**ITB 2018-002 Northbound & Southbound Oak Grove Safety Rest Area Rest Room
Replacements Addendum 6**

DATE: January 4, 2018

1- SHEET C4-NB – PAVING & GRADING PLAN

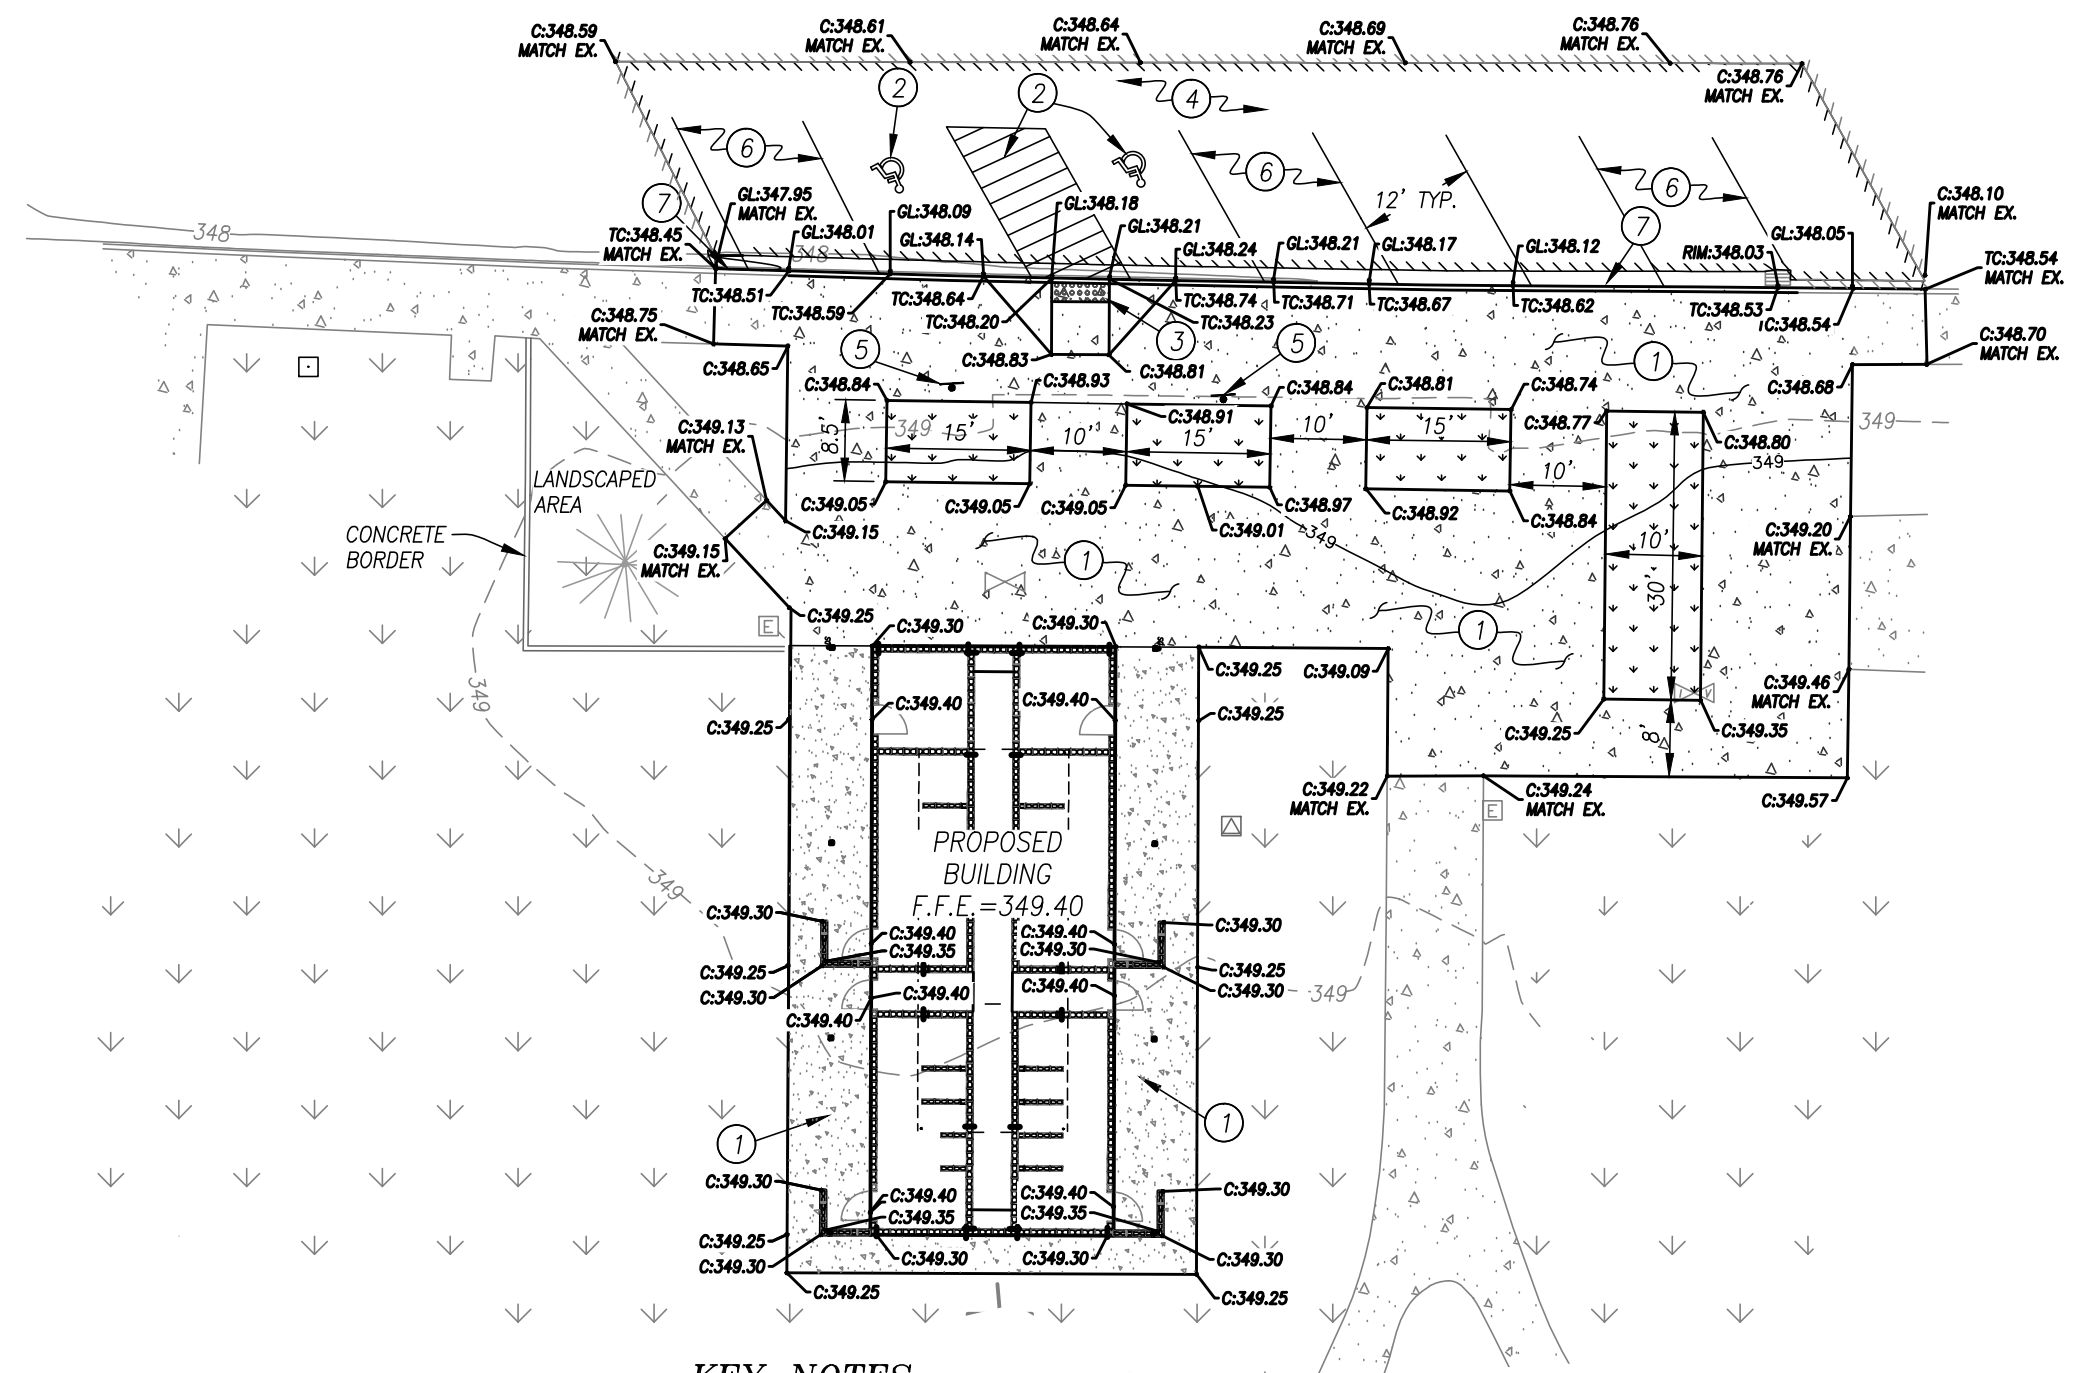
Replace with updated drawing Sheet C4-NB (Removal of note 8).

2- SHEET C4-SB – PAVING & GRADING PLAN

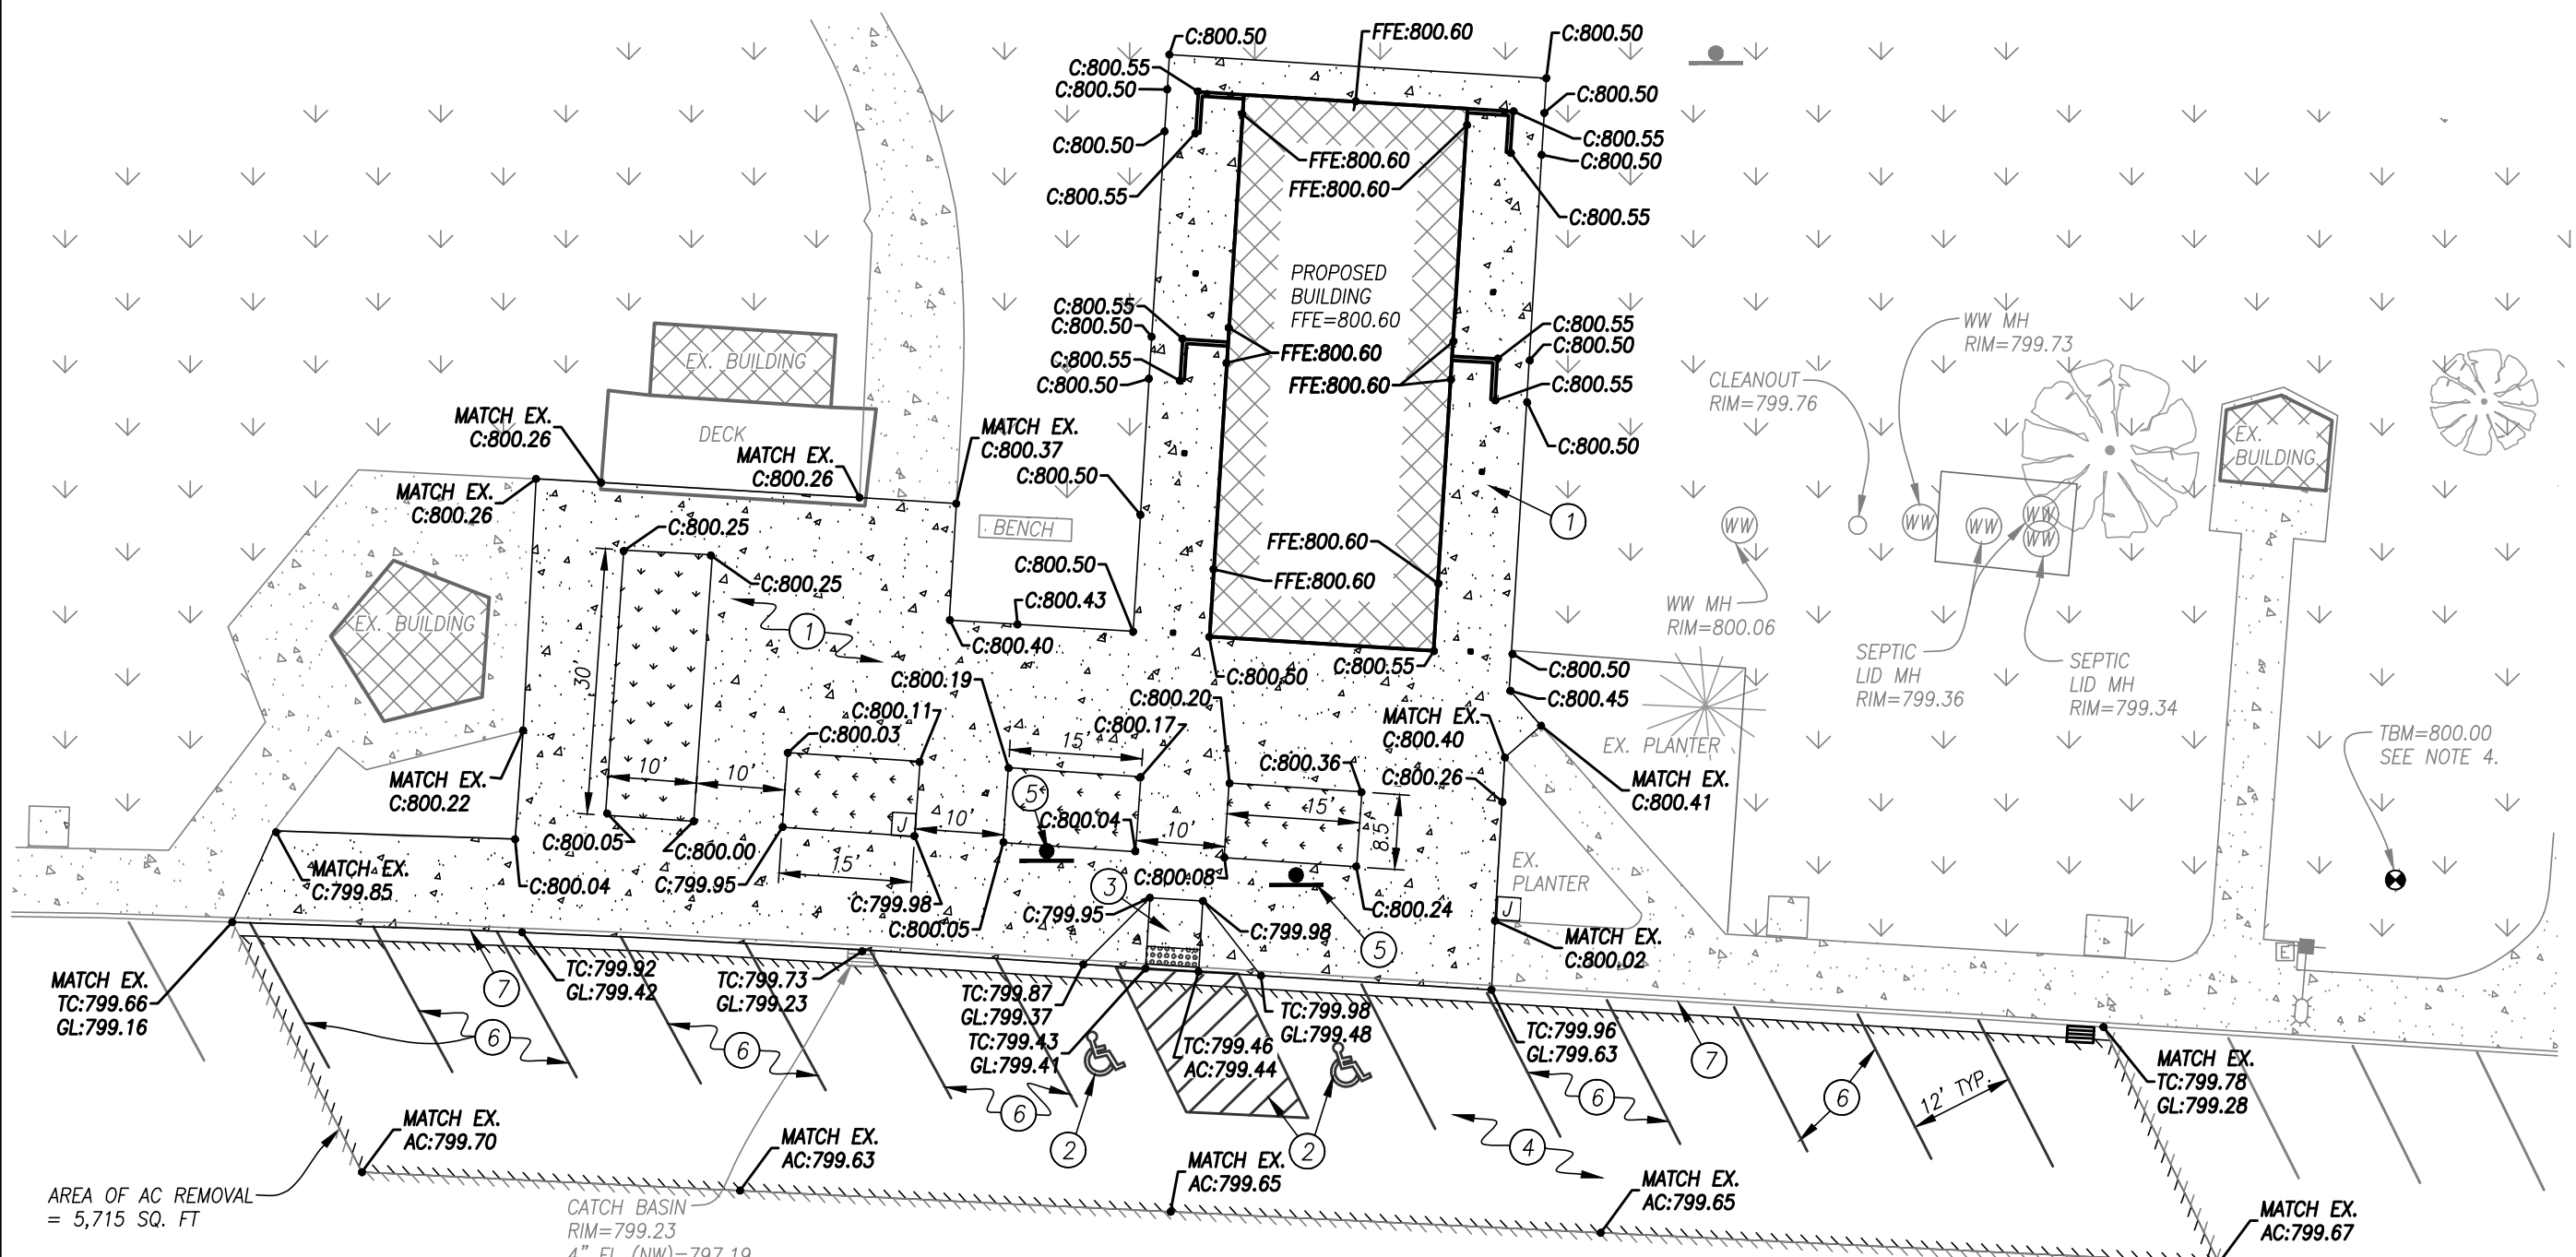
Replace with updated drawing Sheet C4-SB (Removal of note 8).
